WINSOME FILING NO. 3  
EL PASO COUNTY, COLORADO  
CONSTRUCTION DOCUMENTS  
CROSS SECTIONS

PROJECT NO.  
196106001

WINSOME FILING NO. 3  
 EL PASO COUNTY, COLORADO  
 PRE DEVELOPMENT GESC PLAN  
 GEC FINAL PLAN

**7 OUTLET STRUCTURE DETAIL**

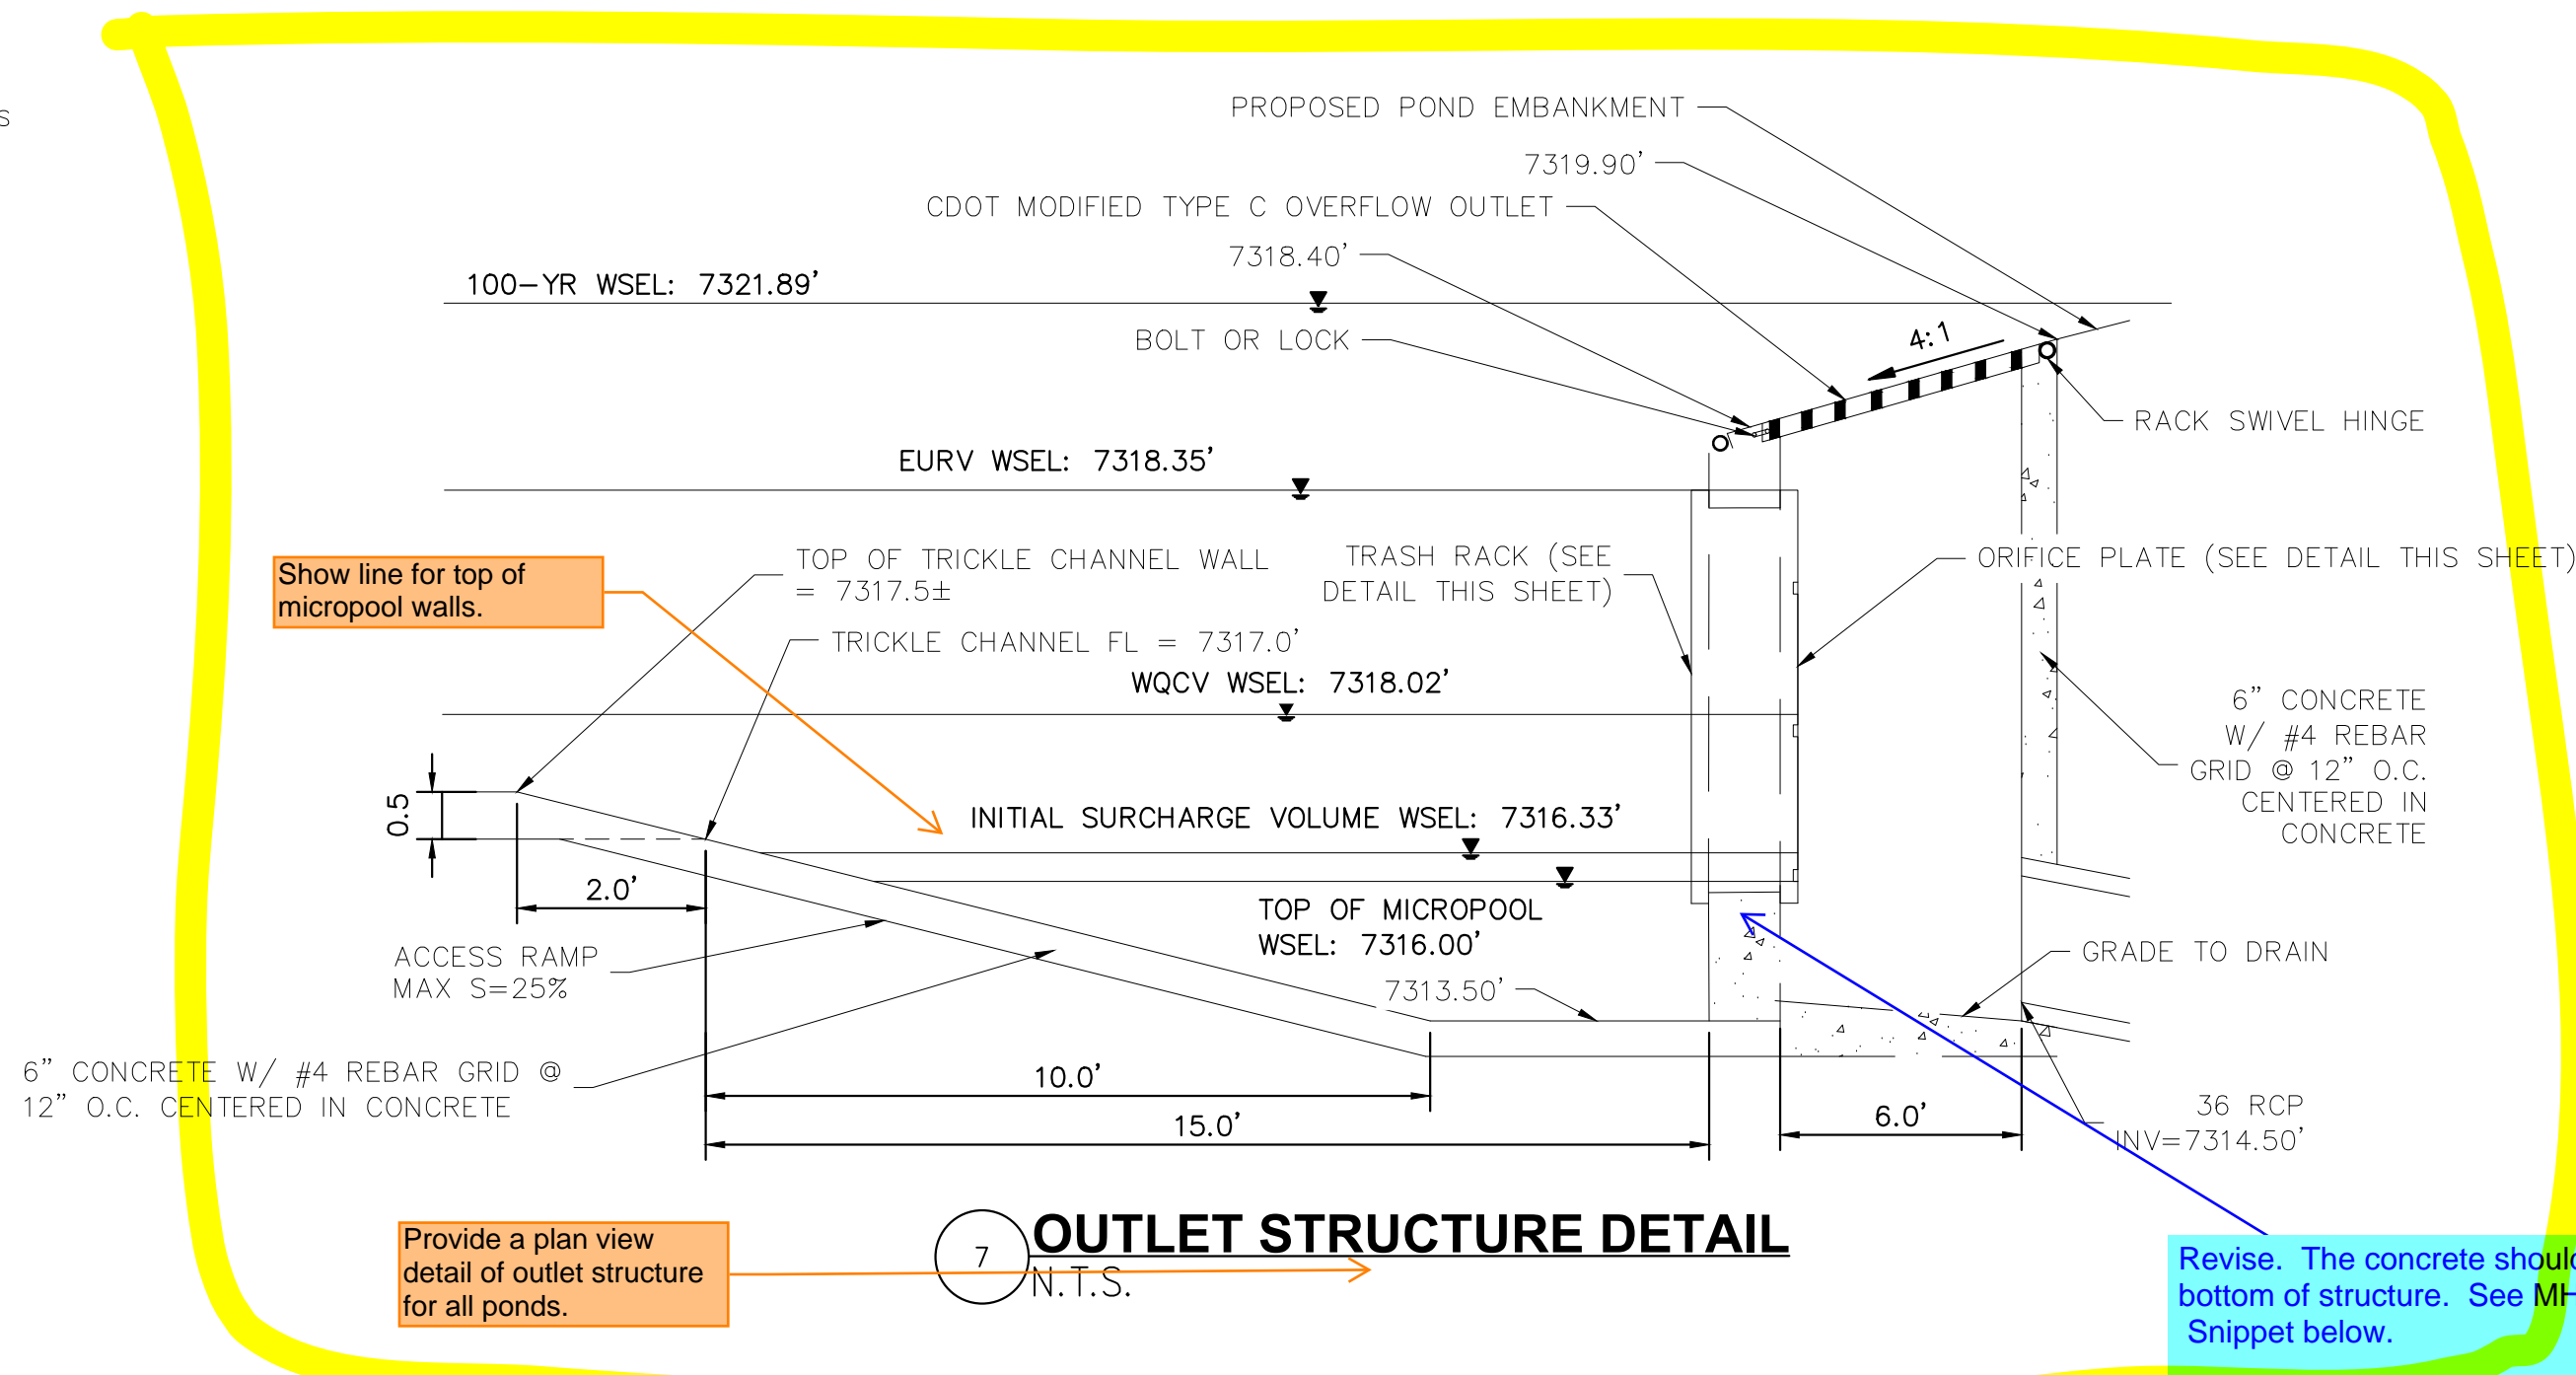
Revise. The concrete should be closer to the bottom of structure. See MHFD Figure OS-5. Snippet below.

Detail revised per MHFD Figure OS-5

12 **ROCK CHUTE TO TRICKLE CHANNEL TRANSITION**  
N.T.S.

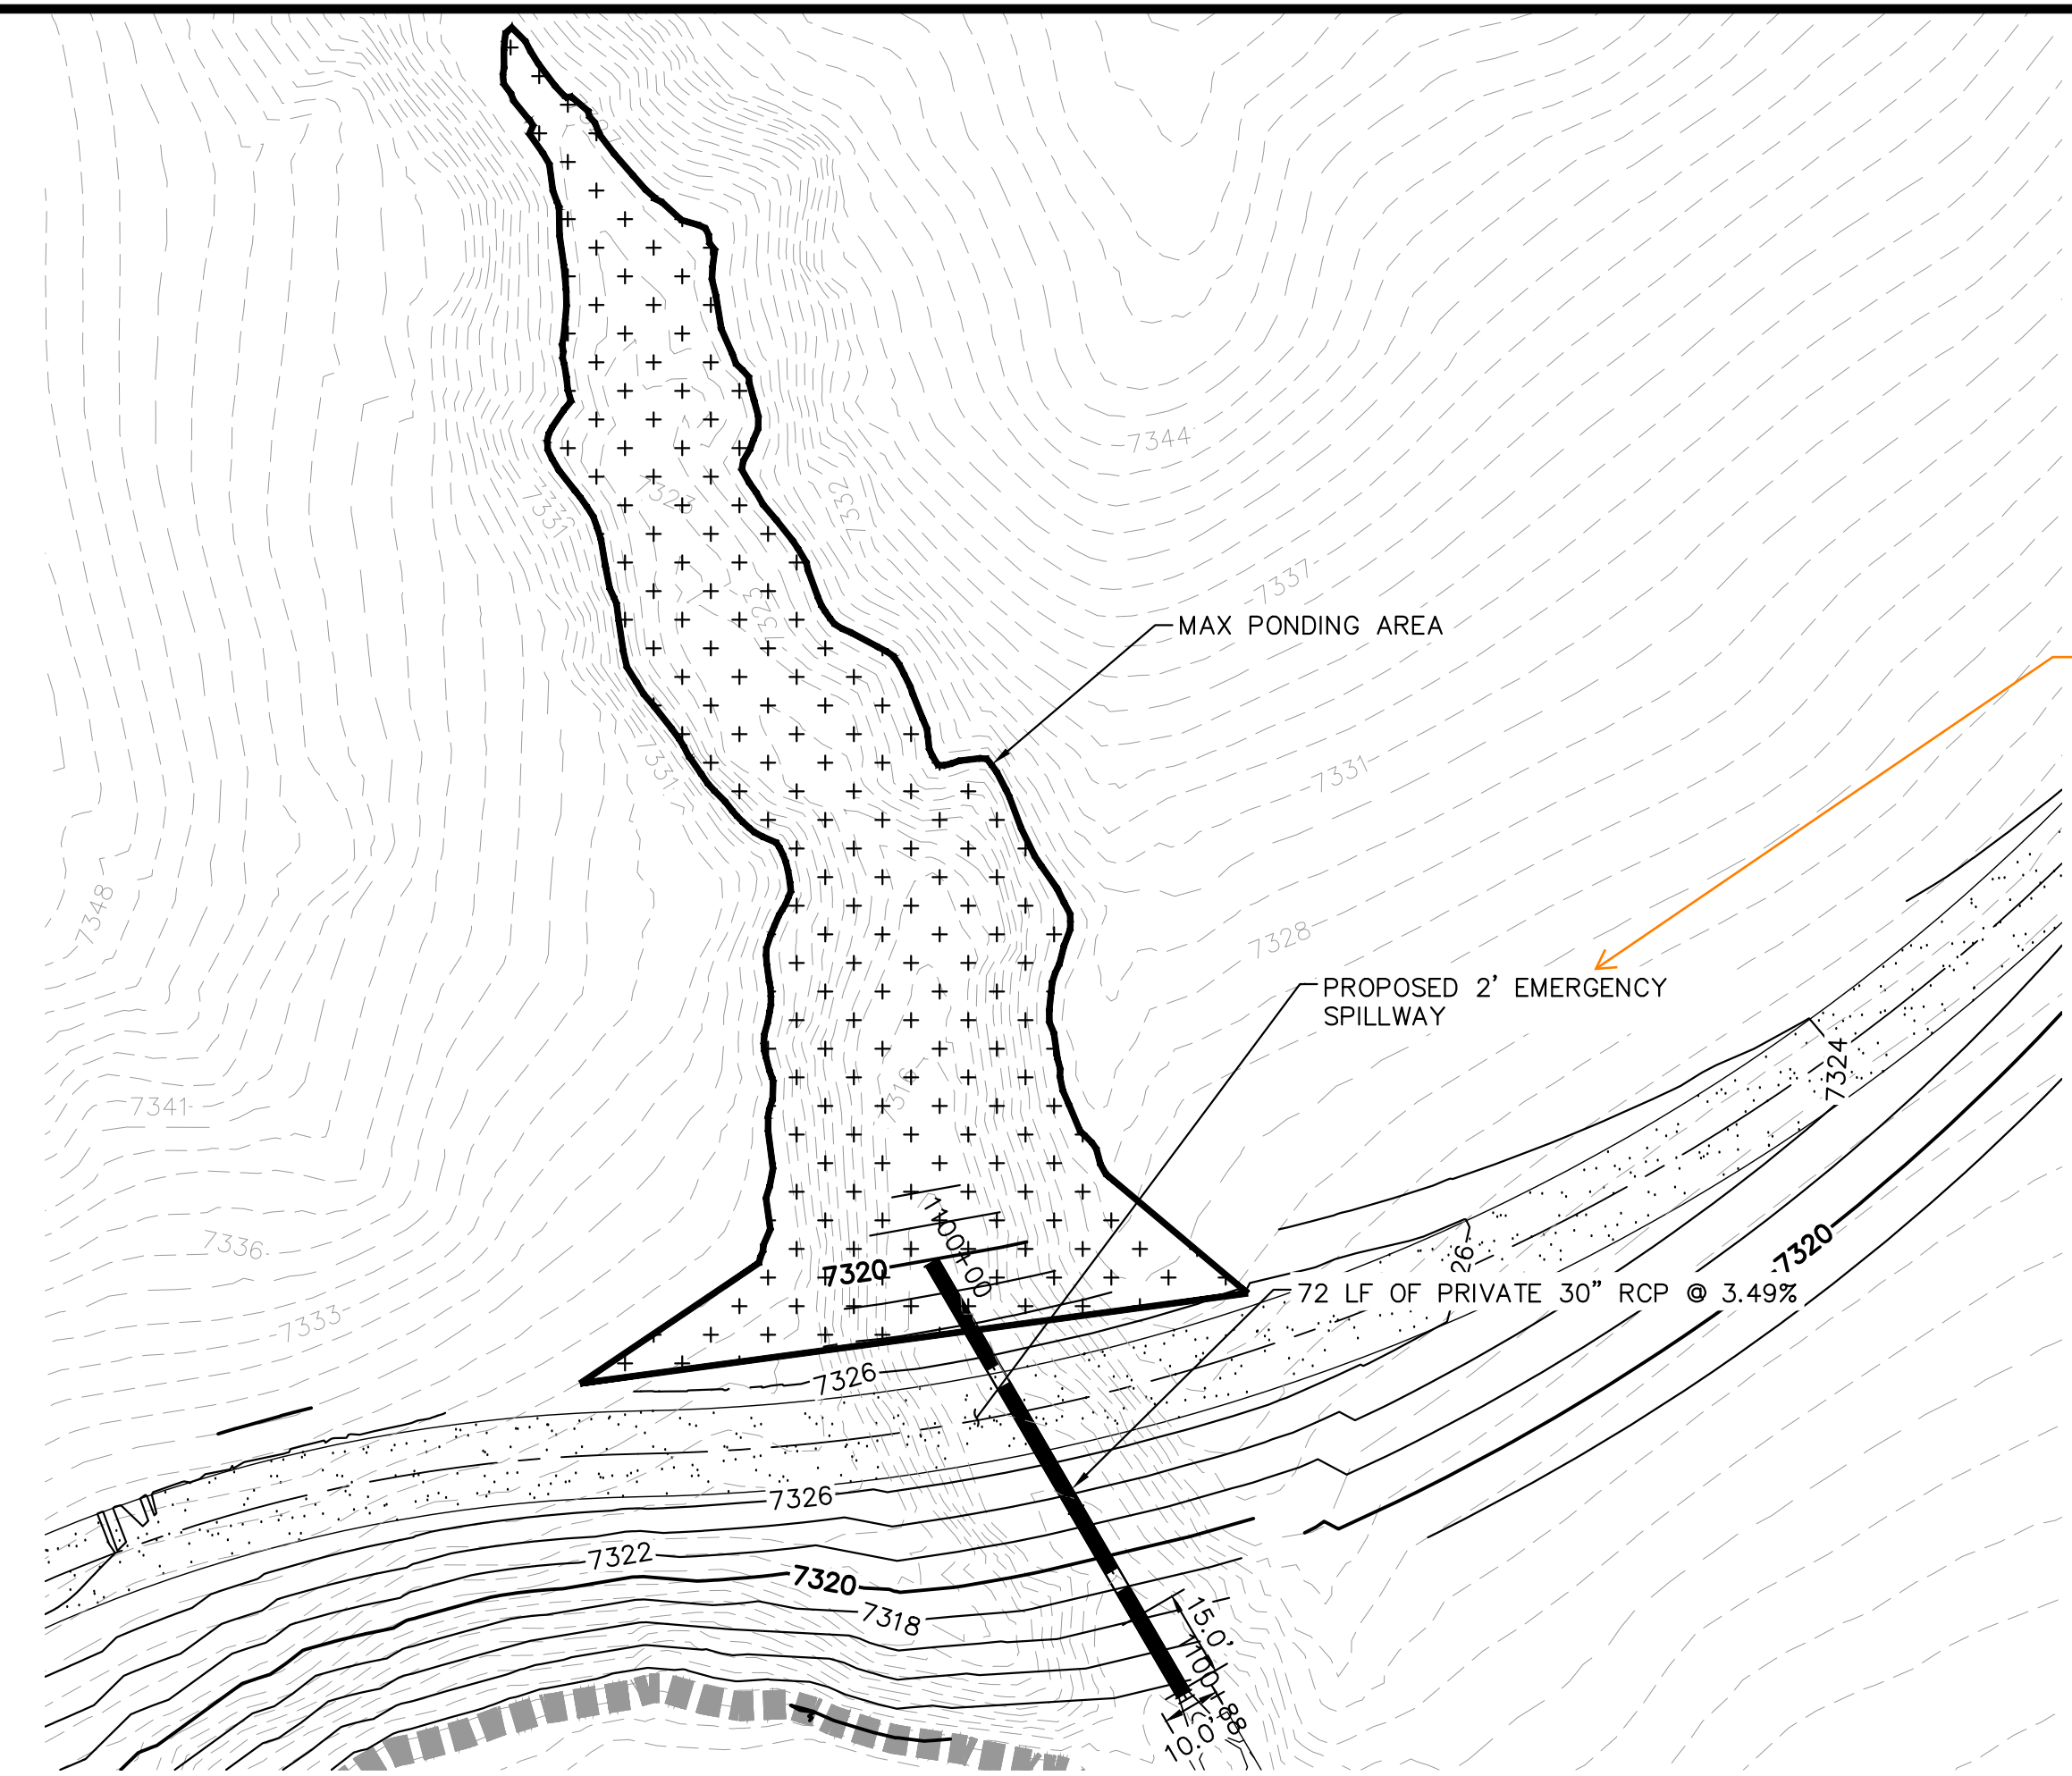
If this is to be used as a forebay, see excerpt from MHFD Detail T-5 below for recommended configuration/design of forebay and revise design accordingly (as applicable):

The forebay outlet should be sized to release 2% of the undetained peak 100-year discharge. A soil riprap berm with 3:1 sideslopes (or flatter) and a pipe outlet or a concrete wall with a notch outlet should be constructed between the forebay and the main EDB. It is recommended that the berm/pipe configuration be reserved for watersheds in excess of 20 impervious acres to accommodate the minimum recommended pipe diameter of 8 inches. When using the berm/pipe configuration, round up to the nearest standard pipe size and use a minimum diameter of 8 inches. The floor of the forebay should be concrete or lined with grouted boulders to define sediment removal limits. With either configuration, soil riprap should also be provided on the downstream side of the forebay berm or wall if the downstream grade is lower than the top of the berm or wall. The forebay will overtop frequently so this protection is necessary for erosion control. All soil riprap in the area of the forebay should be seeded and erosion control fabric should be placed to retain the seed in this high flow area.

This is a typical comment about all Rock Shutes into all ponds.

rock chutes with forebay applications were modified to have a distilling basin above ground with a rock berm and notch to be in compliance with all MHFD criteria.

**PERMANENT SEDIMENT BASIN H5B OUTLET PIPE PLAN AND PROFILE**

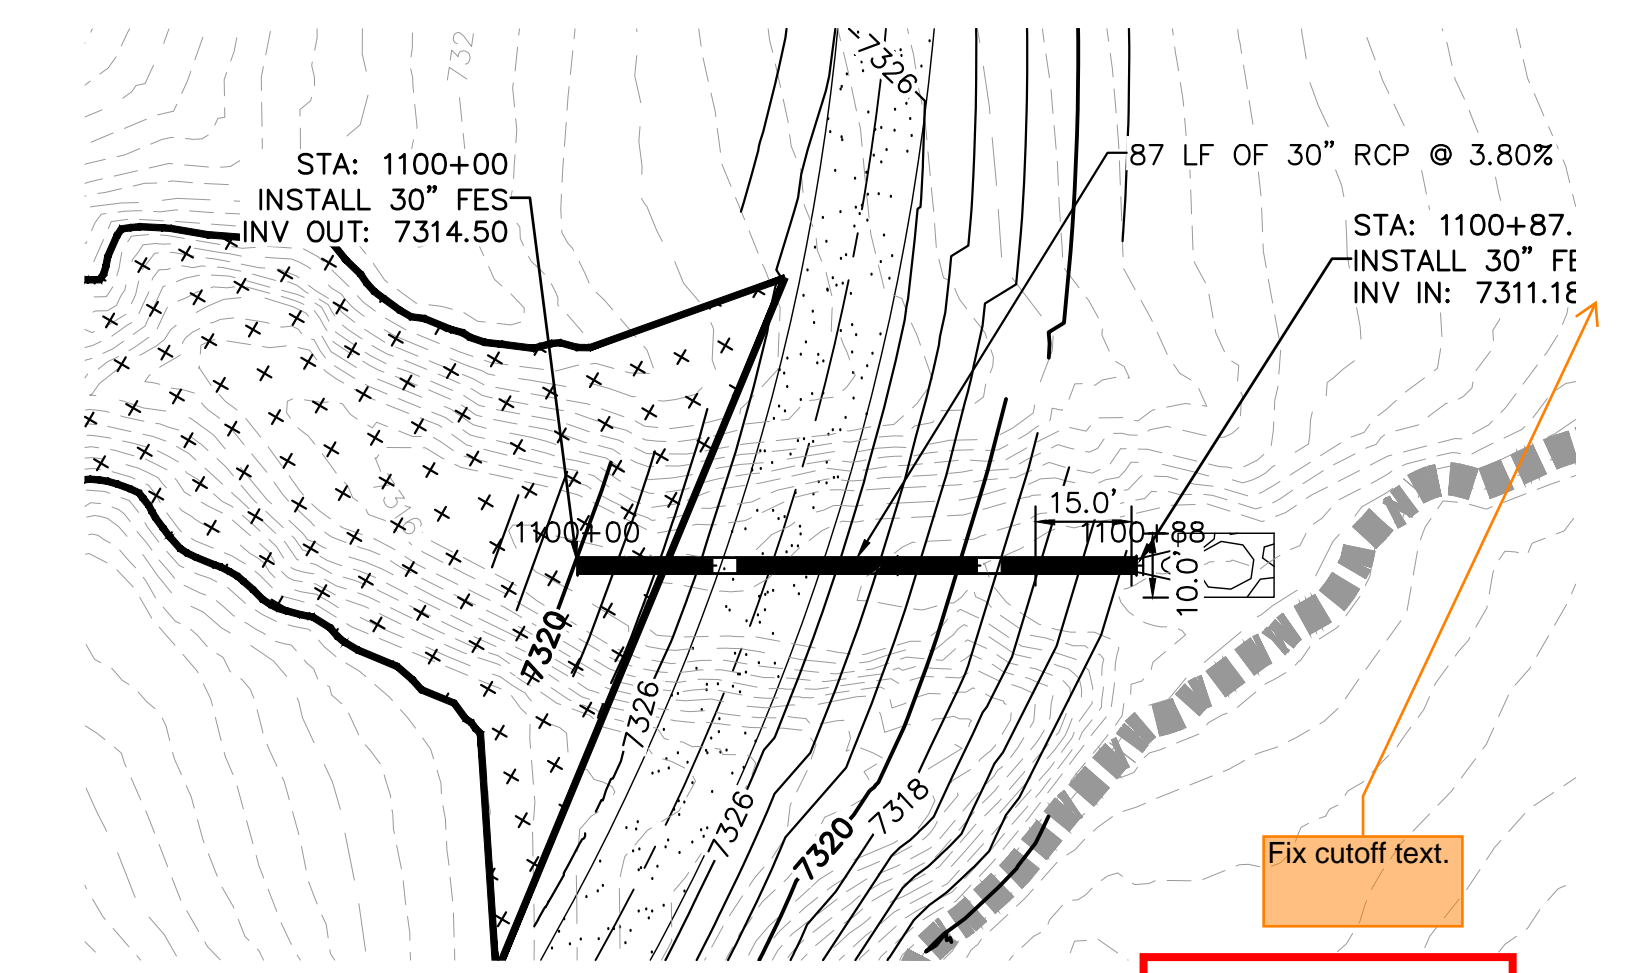
Recommend deleting if final design and construction of the permanent sediment basin is included with the early grading application so it avoid duplicates that may not be consistent with each other.  
On the Grading plan add a note referencing the early grading construction plan for construction details.

Provide detail for this spillway. And it should match specifications shown on pdf pg 357 of FDR.

Sediment Basin H5B is now shown in the Early Grading Plans.
